RE: **Lot 12 Block 7 Unit 5 SAD 227**
8035 Kibo NW
Grading and Drainage Plan
Engineers Stamp Date 12/10/2020 (E10D090)
Pad Certification Date 12/10/2020

DRAINAGE AND TRANSPORTATION INFORMATION SHEET (REV 6/2018)

ENGINEER'S SEAL	LOT 12 BK 7 Un 5 VC 8035 KIBO DRIVE, N.W.	DRAWN BY DEM
DAVID SOULE NEW MEXICO REGISTERED PROFESSIONAL ENGINEER 14522 12/10/20	GRADING AND DRAINAGE PLAN	DATE 12-10-20
	Rio Grande Engineering 1606 CENTRAL AVENUE SE SUITE 201 ALBUQUERQUE, NM 87106 (505) 872-0999	LOT 12 BK 7 Un 5 VC.dwg
		SHEET # C1
		JOB #

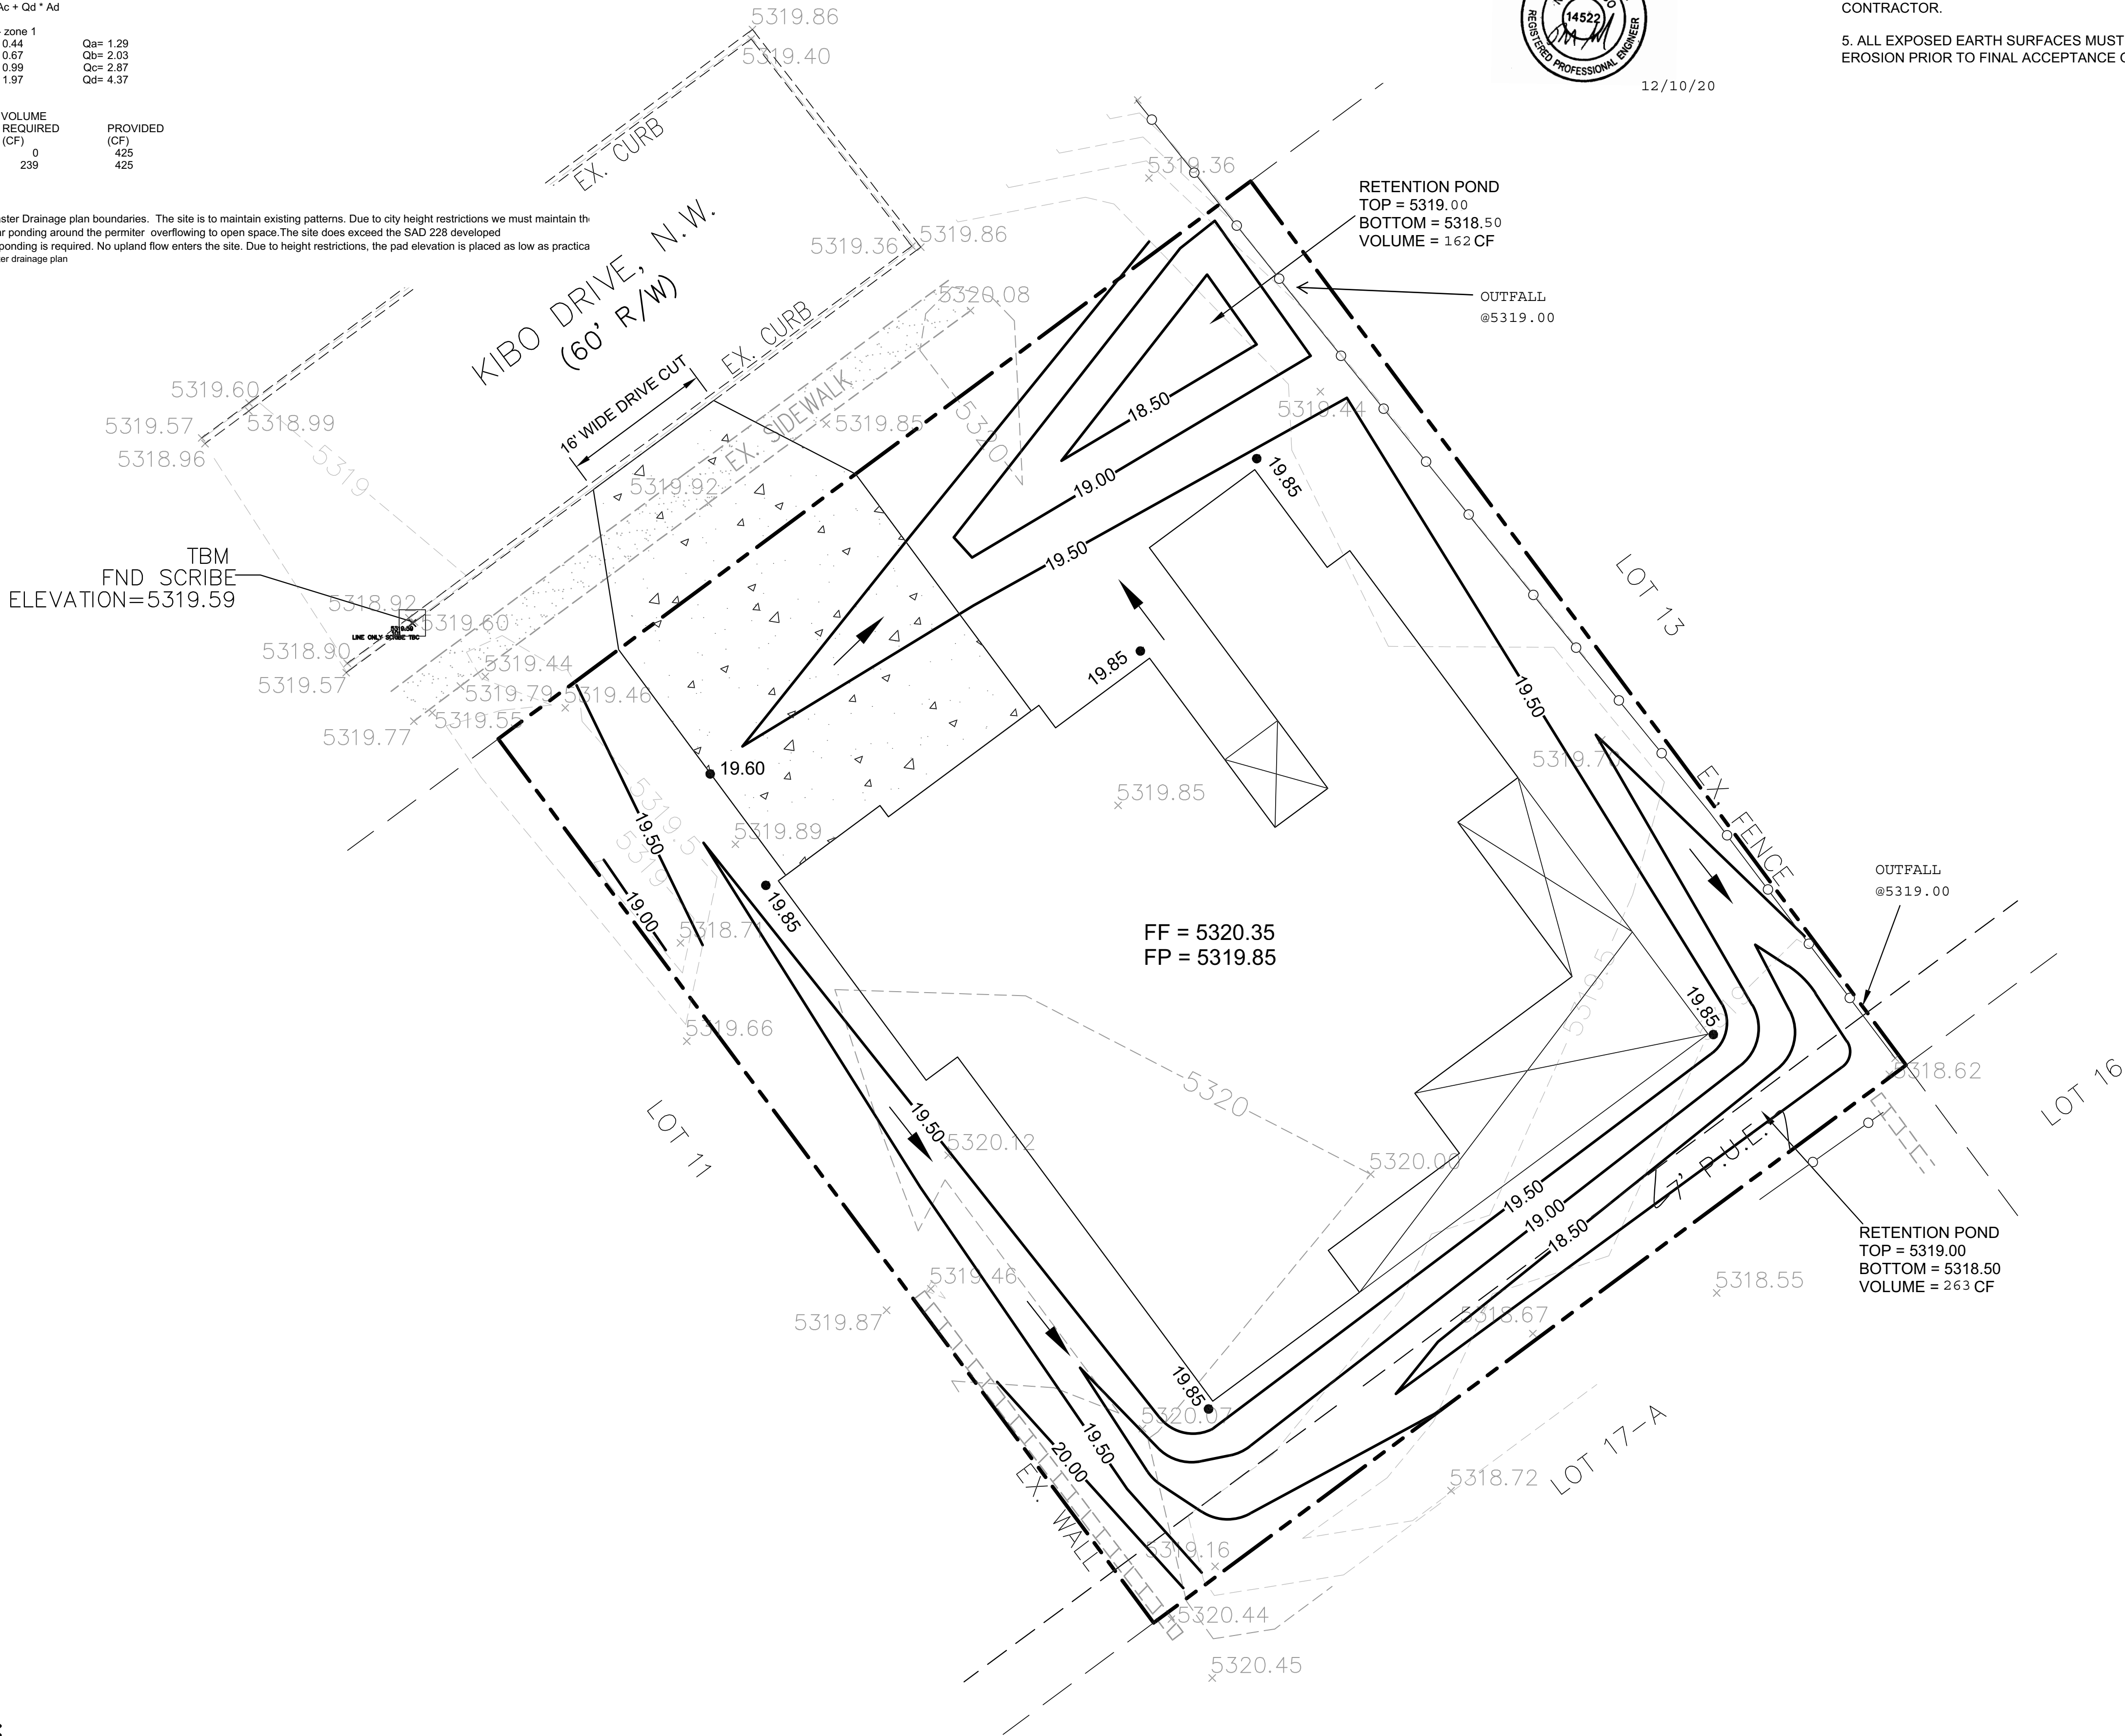
Based upon the information provided in your submittal received 12/10/2020, this plan is approved for Building Permit.

Reiterate to the Owner/Contractor that a separate permit for a garden/retaining wall must be obtained, with the approved G&D plan and Pad Certification. Also, let the owner/contractor know that if a pool is to be added in the future the G&D plan will need to be modified showing the location of the pool and the land treatment differences.

Prior to Certificate of Occupancy release, Engineer Certification per the DPM checklist of this plan will be required.
